Technical Bulletin

Number 122
November 1982

Tip Handling Stop Block Kit 673041

Models: 20D, 35D and 60D Carton Clamps

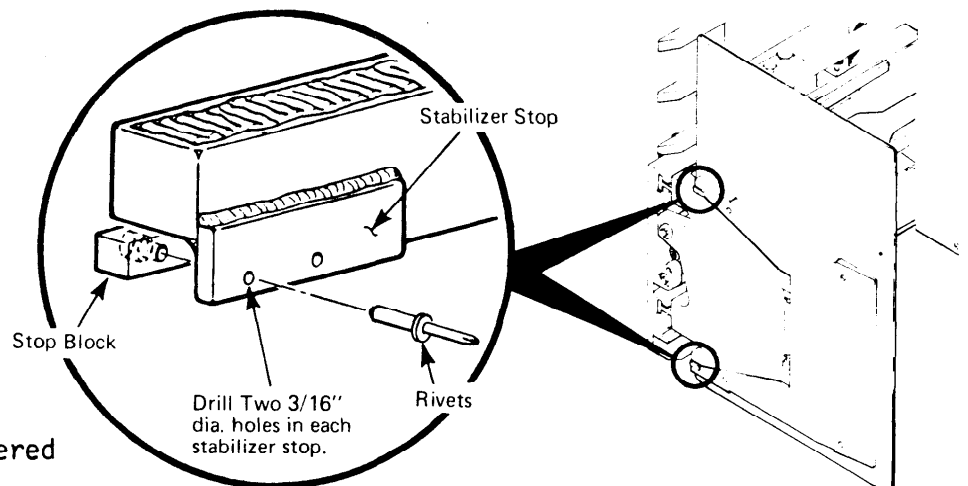
Problem: In certain applications when clamping partial unit loads or loads that extend beyond the front edge of the contact pads, the clamping force at the front of the contact pads is not sufficient to securely clamp the load.

Solution: Install Service Kit 673041 which contains 4 stop blocks, required rivets and installation instructions.

1. Drill the upper and lower stabilizer stops on both arms with two 3/16" dia. holes. Hole locations are specified in the installation instructions.
2. Fasten the stop blocks to the stabilizer stops with the rivets provided.
